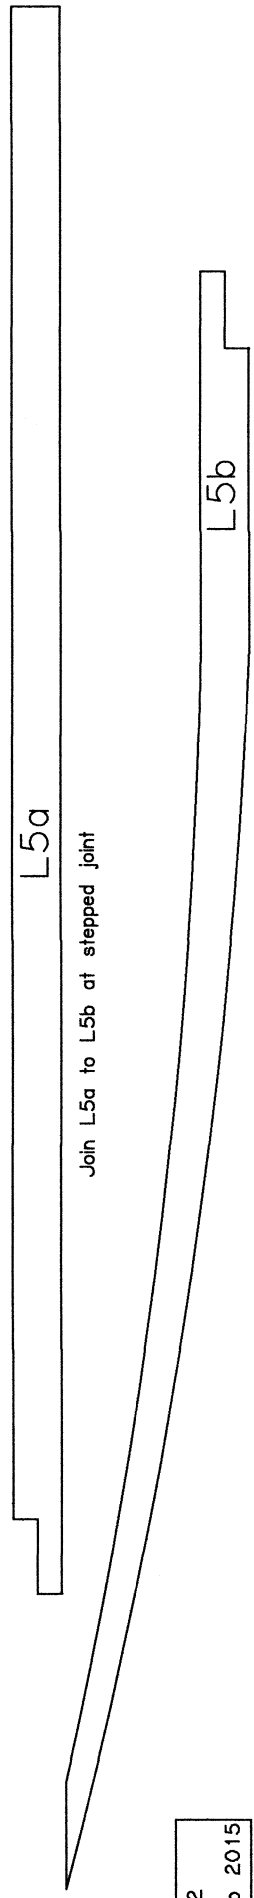
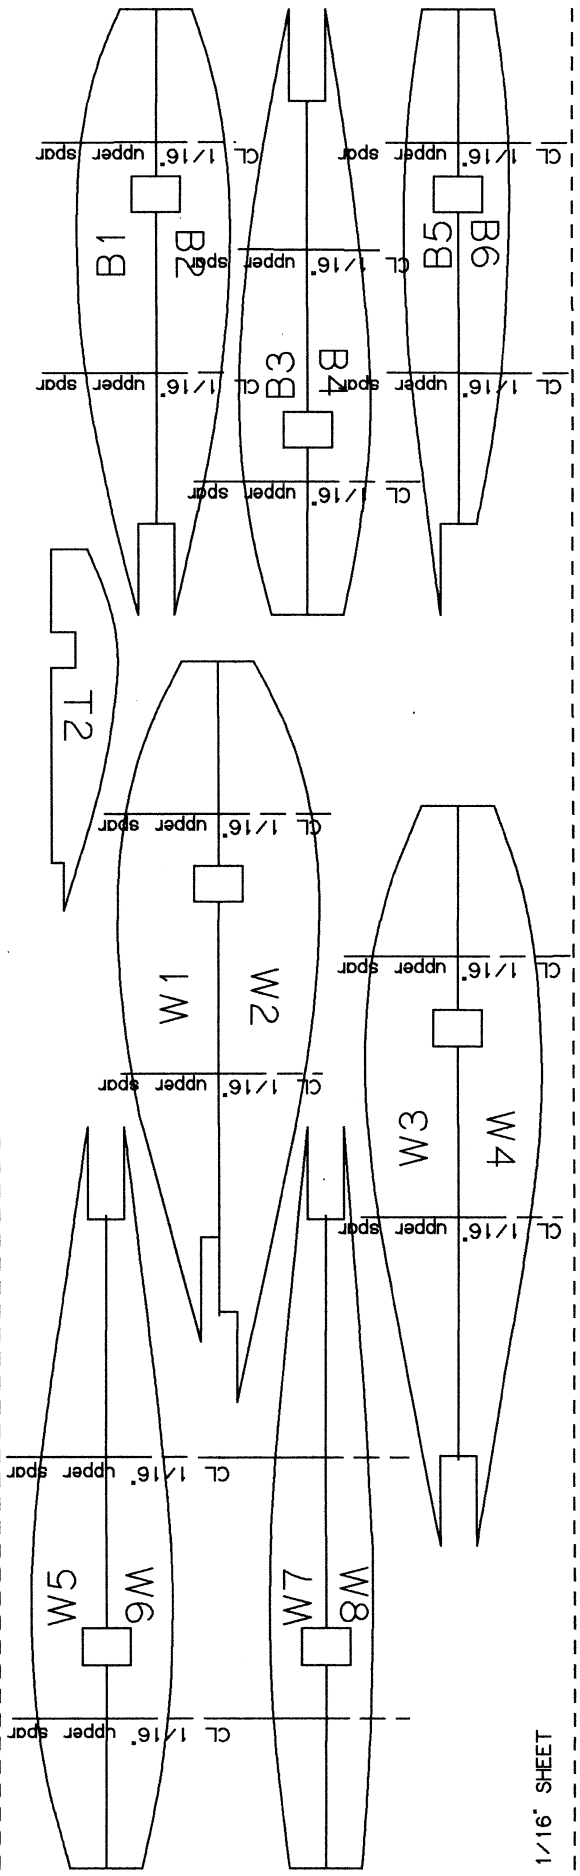
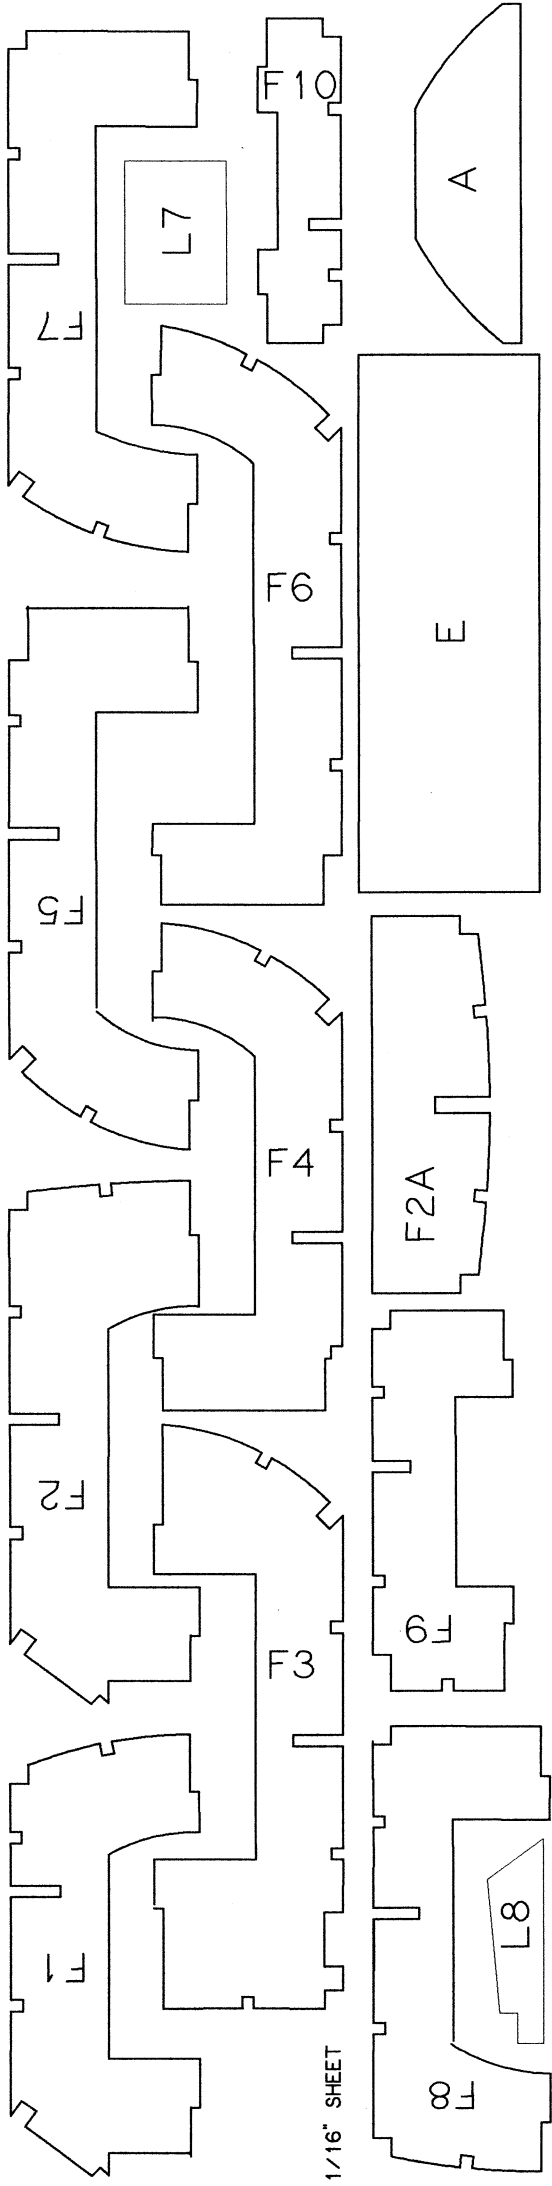
Formers and ribs were drawn from wood pattern and amended where slots and notches were not aligned as should be.

Join L5a to L5b at stepped joint
